MINUTES OF THE ACRS THREE MILE ISLAND SUBCOMMITTEE
MEETING
Student Center, Pennsylvania State University Campus
Middletown, PA
June 6-7, 1979

ACRS-1644

The ACRS Three Mile Island Subcommittee met in Middletown, Pa. to discuss details of the Three Mile Island accident with the operators of the plant, Metropolitan Edison and its parent company, General Public Utilities, and with the NRC Staff. The notice of the meeting, containing the proposed agenda, appeared in the Federal Register, p. 29765, Vol. 44 No. 100 Tuesday, May 22, 1979. (Attachment A). The Tentative Detailed Schedule is attached (Attachment B), as well as a list of attendees (Attachment C). Copies of presentation slides and supporting documents are attached as noted below. There were no requests to make oral statements and no written statements received although the Committee had been informed that a Mr. Bar n of Boston, Mass. would submit a statement.

BASE CASE SUMMARY (REVISION 3)

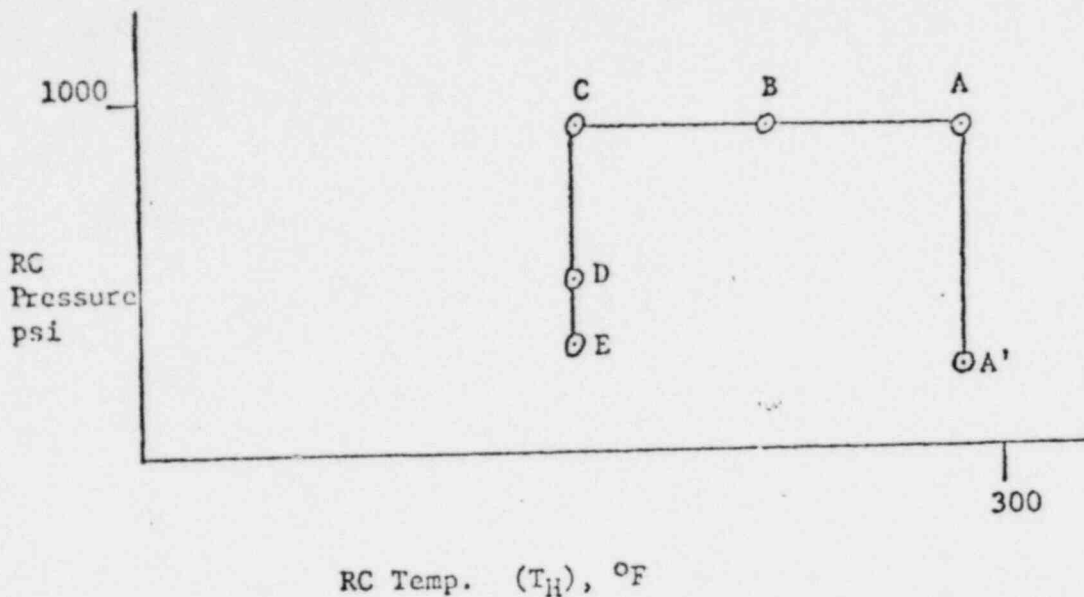
The start is represented by point A on Slide O-1 (just below 300^oF, slightly below 1000 psi). The plan was to cool down and then to depressurize and transition to natural circulation.
